Amendments to the Drawings

Sheets 1 of 3 and 3 of 3 have been amended.

FIG. 1

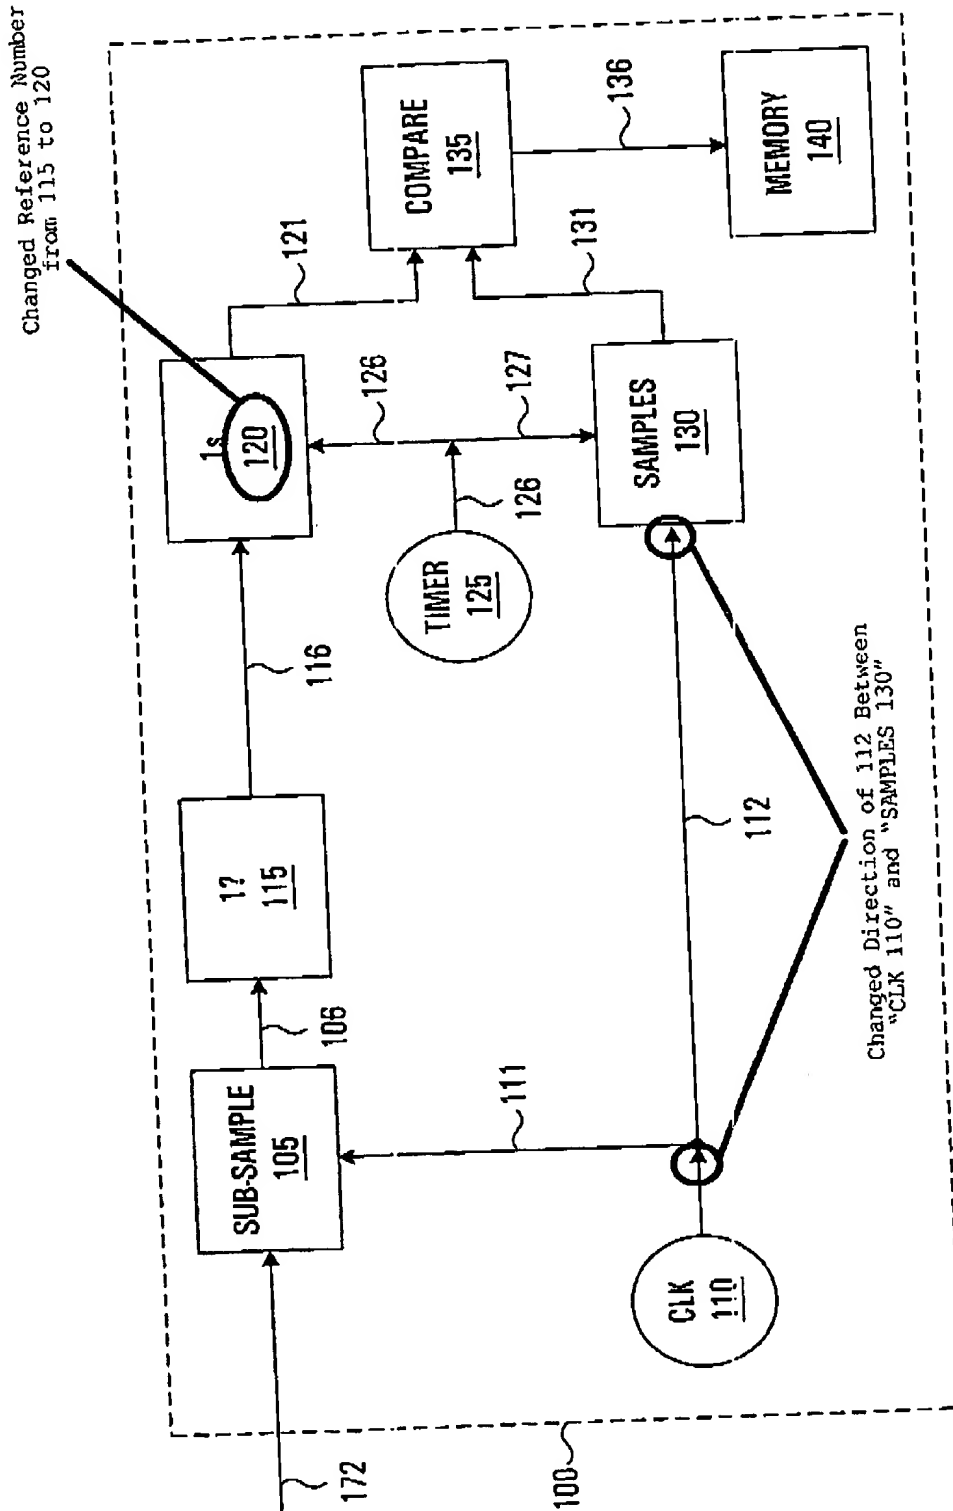
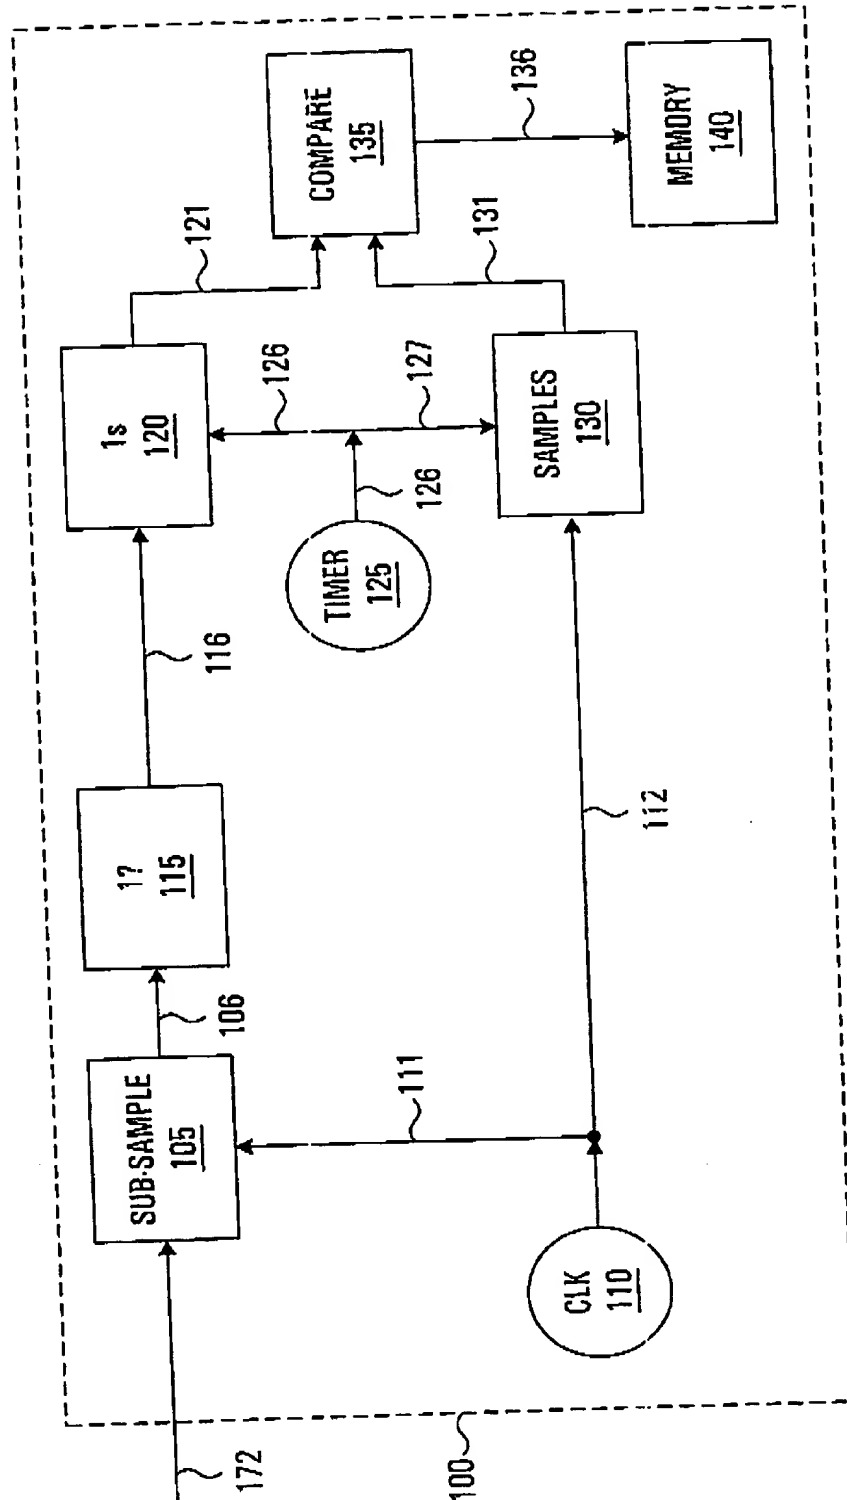
Figure 1 on sheet 1 of 3 has been amended to correct the numerical identifier associated with the functional block labelled as "1s" from 115 to 120. The same amendment has been made to Figure 3 on sheet 3 of 3.

Also in Figure 1 on sheet 1 of 3, the arrowhead located adjacent to and pointing in the direction of "CLK 110" on line 112 has been removed and an arrowhead has been added that is located at the junction of lines 111 and 112 pointing away from the direction of "CLK 110". A second arrowhead has been added that is located on line 112 adjacent to and pointing in the direction of "SAMPLES 130".
